SECTION 00 91 11.01 - ADDENDUM 001

**20210388 - BL107 BIOLOGY BUILDING -
REPLACE AHU 6**

A/E PROJECT 5-6669

1.1 SHEET M2.2.06 - SIXTH FLOOR HVAC & ELECTRICAL PLANS - ROOM A693B (REISSUED)

1
M2.2.06
SIXTH FLOOR HVAC & ELECTRICAL PLAN - ROOM A693B
1/4\" = 1'-0\"

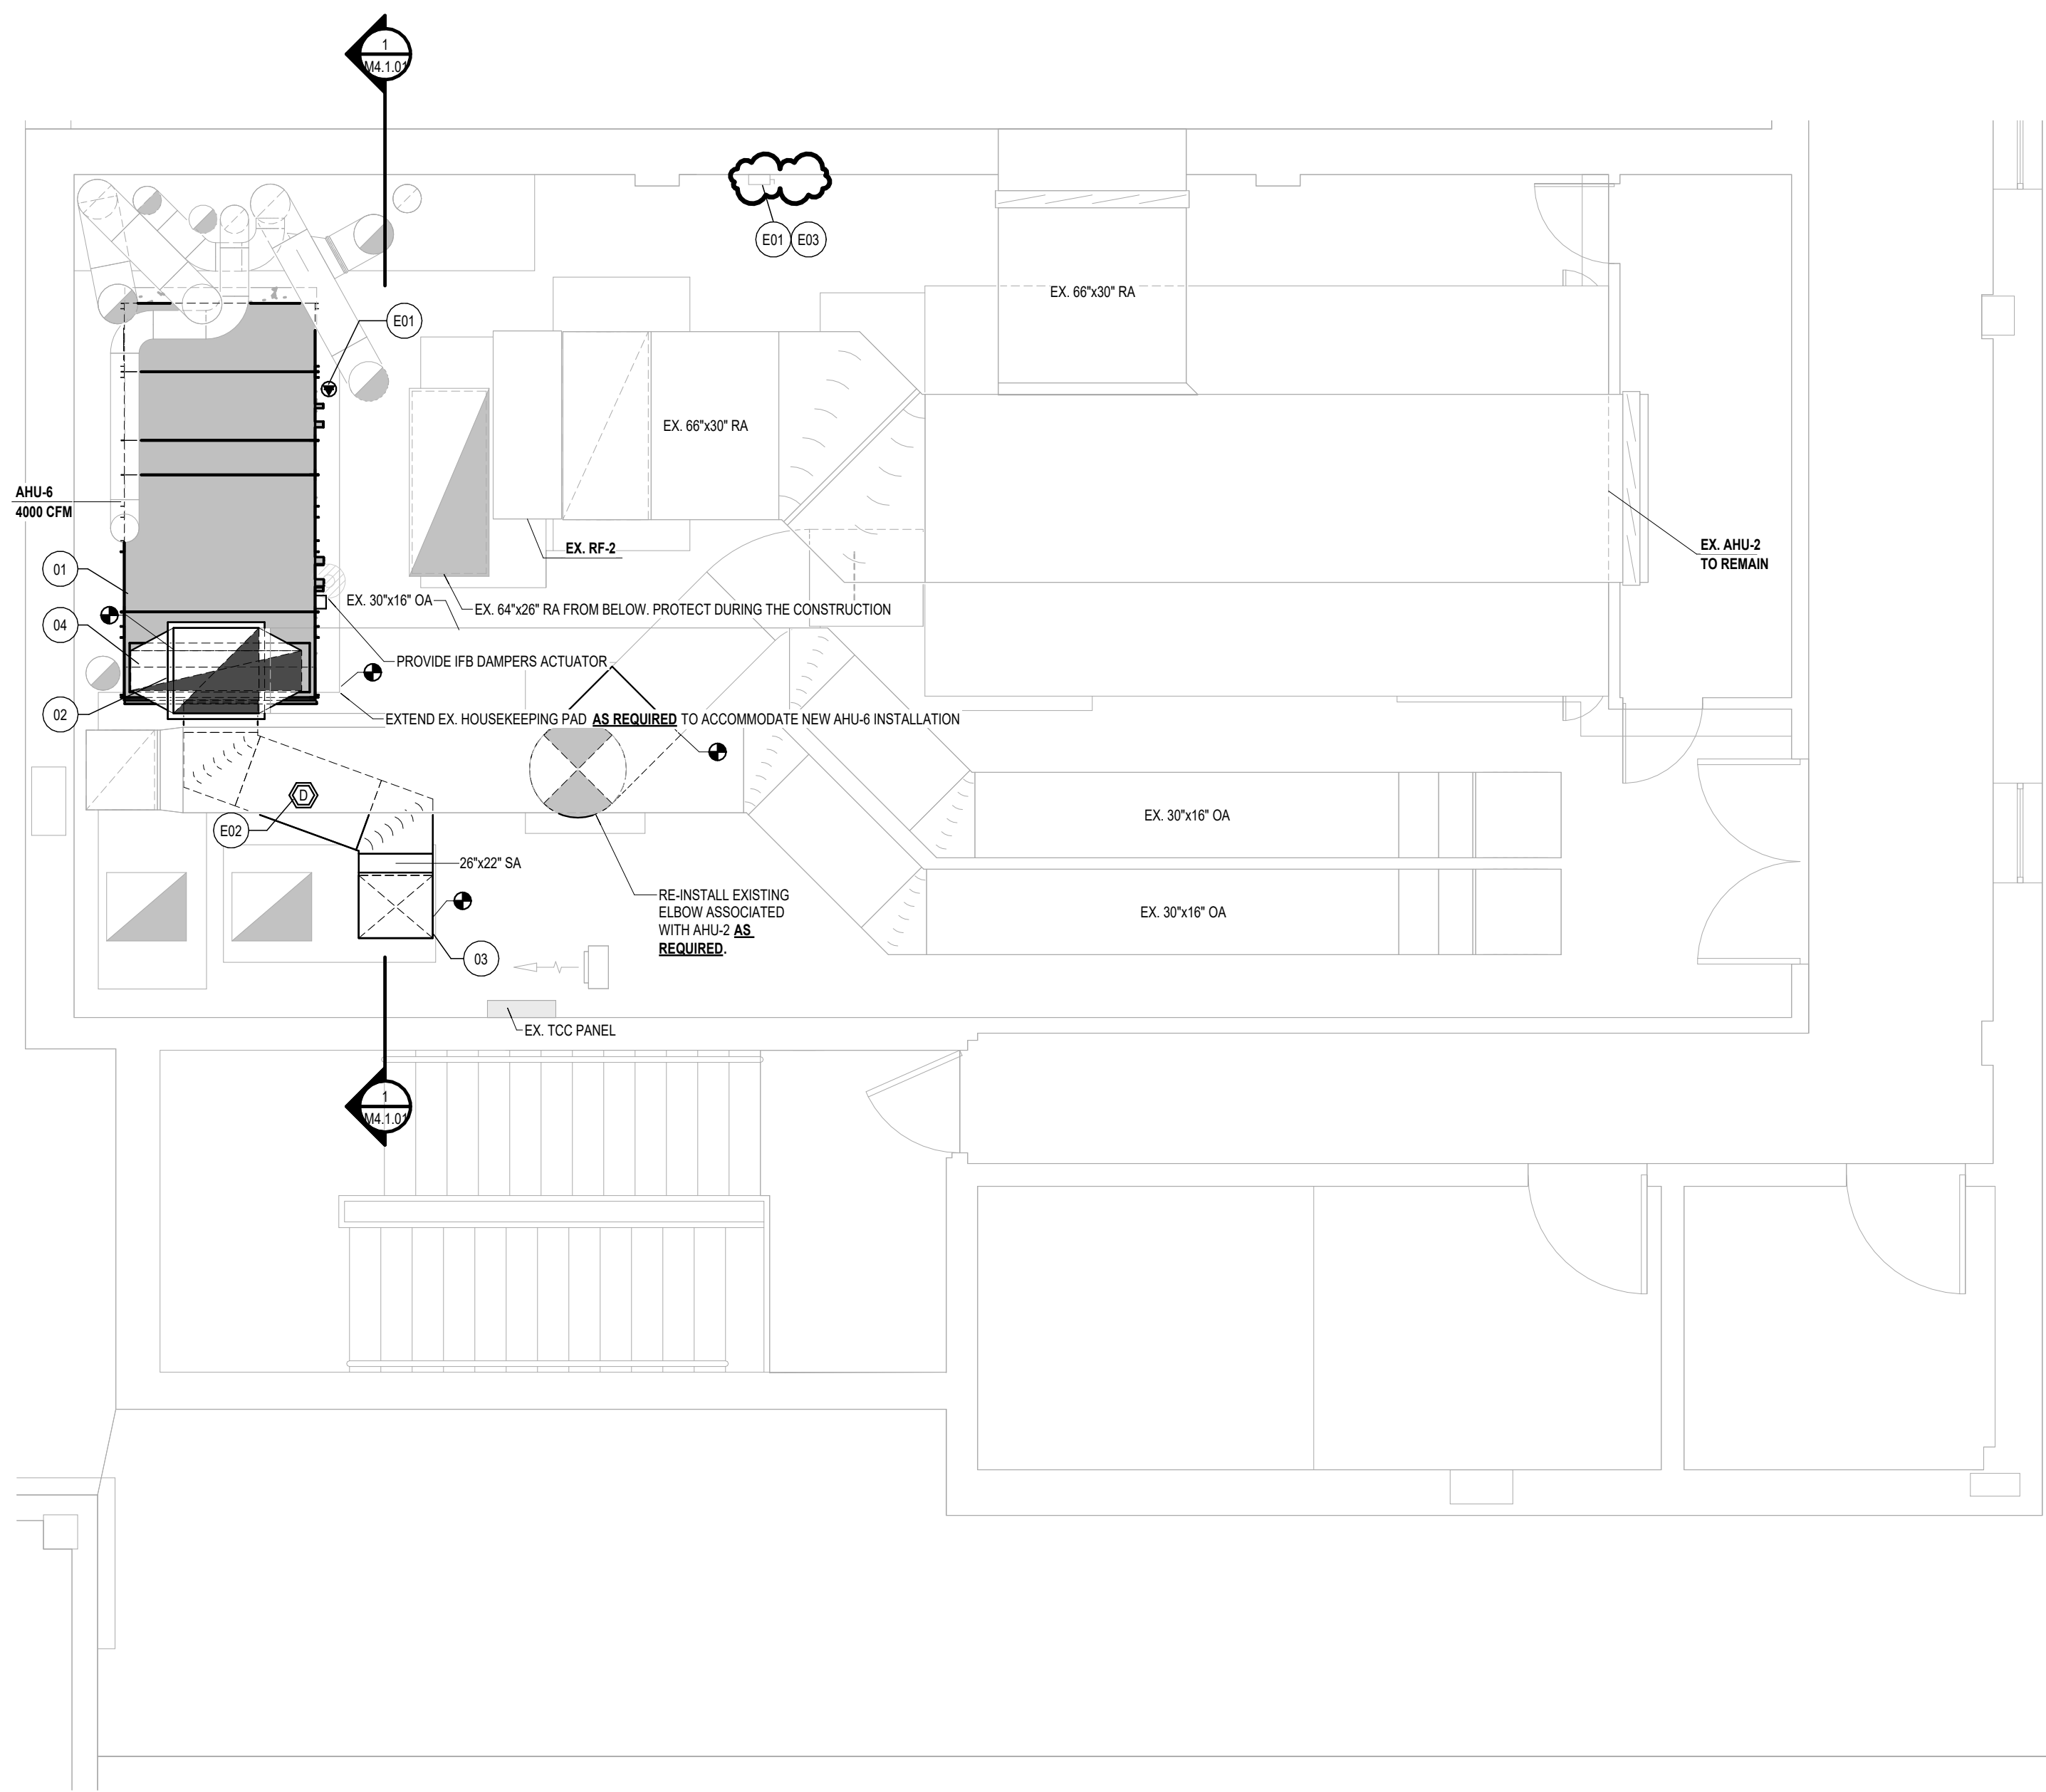
- A. Removed duplicate disconnect switch in new work view.
